**Sub: Clarifications No. 01 Notice for Design, Supply, Construction, Erection, Installation, Testing and Commissioning of 05 Nos. 33/11kV New GIS Substation, 02 Nos. 33/11kV Substation (GIS Up-gradation), 33kV Bay-Extension at 02 Nos. Substation and 33kV Underground Cable Double Circuit Source Line with Civil and other related works including automation of the Sub-station (SAS) on Turnkey Basis under Power Distribution System Development, Chattogram Zone (2nd Phase), BPDB, Chattogram (GD-1, Lot-3).**

Addendum-1

International Tender Ref. No.: 27.11.0000.101.14.035.22-3233, Dated- 20/07/2022 for "Design, Supply, Construction, Erection, Installation, Testing and Commissioning of 05 Nos. 33/11kV New GIS Substation, 02 Nos. 33/11kV Substation (GIS Up-gradation), 33kV Bay-Extension at 02 Nos. Substation and 33kV Underground Cable Double Circuit Source Line with Civil and other related works including automation of the Sub-station (SAS) on Turnkey Basis under Power Distribution System Development, Chattogram Zone (2nd Phase), BPDB, Chattogram." (LOT-3)

SINGLE LINE DIAGRAM OF UPGRADATION OF BARAULIA 33/11KV GIS SUBSTATION (3150 Amperes Double Bus)

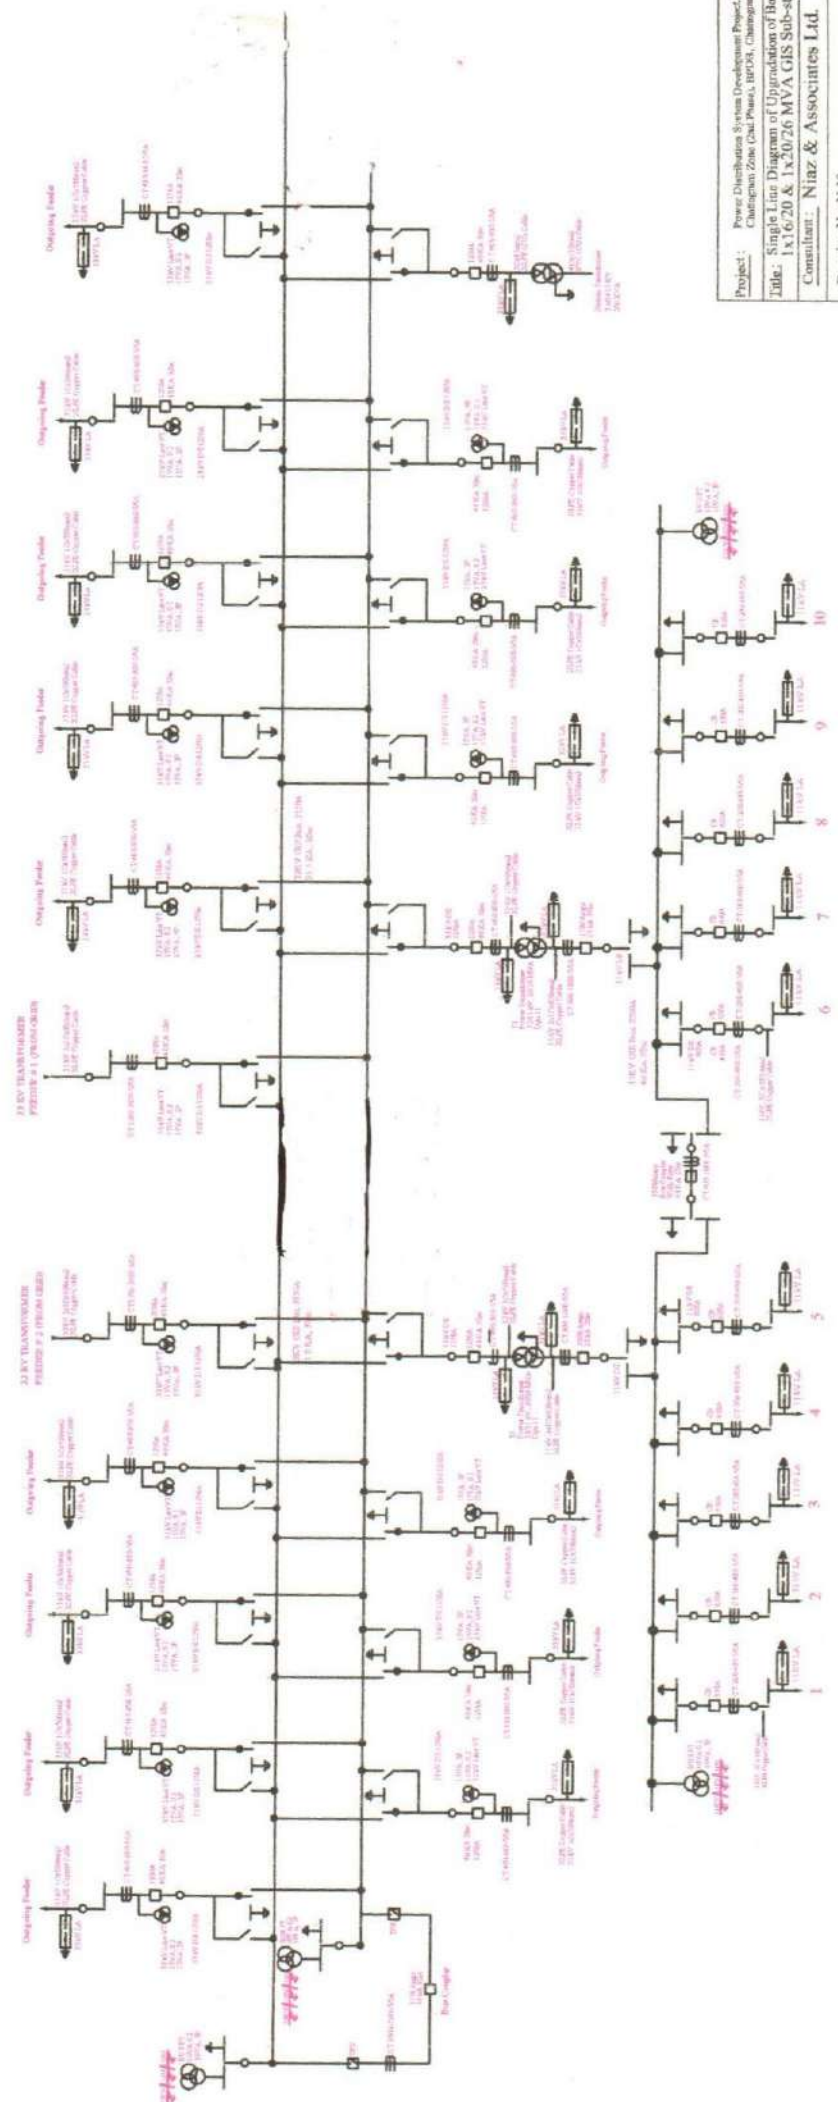
| Sl. No. | Tender Clause & Page No.  | Existing as in Tender Document   | Clarification Asked  | Amendment/ Clarification/ Remarks  |
|---------|---|--|--|--|
| 53      | Price Schedule, 33kV GIS Line Item, Description of Items for Up-gradation of GIS Substation at Baraulia | Description of Items for 33kV GIS mentioned that, GIS cubicles Bus Coupler Breaker with Riser (Bus Coupler with Riser) (3150 A) - 1 No.  | We understood that, 33kV GIS for this substation is Double Bus Bar system. As per the indicative Single Line Drawing, 1 set of Bus sectionalizer shown and in Price Schedule these 1 set is mentioned as Bus Coupler.<br><br>Kindly note that, if this 1 set is Bus Sectionalizer, there are also requirement of 2 nos. additional Bus Coupler Panels of 3150A (1 no. for each Bus Section) which are not mentioned in the Price | No bus section required. Only one set of Bus Coupler with riser required. for Double Bus system (Corrected indicative drawing given as attachment-1 of this clarification) |
